Access Compliance Report Public Rights-of-Way (Curb Ramps)

Main Street: SANDERSTEAD_RD Cross Street: HOLT_AVE Location: NW

ADA ID: RPAT211007141902 Ramp Type: Type 1 - Perpendicular Diagonal Initial Pass/Fail: Pass Overall Compliance: No Severity Score: 22

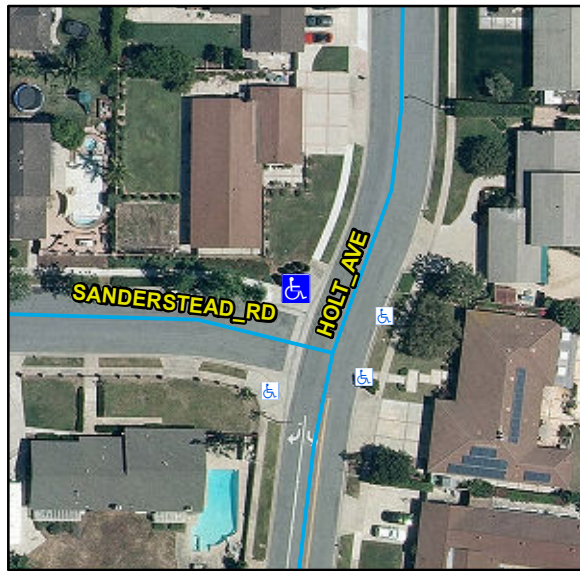
R304.2.2, R204.3, R304.2.1, R304.2.2-Perp, R304.3.2-Para, R304.5.3, R305, STD 1115

Remove & Replace Curb Ramp With Two New Directional Ramps or Equivalent.
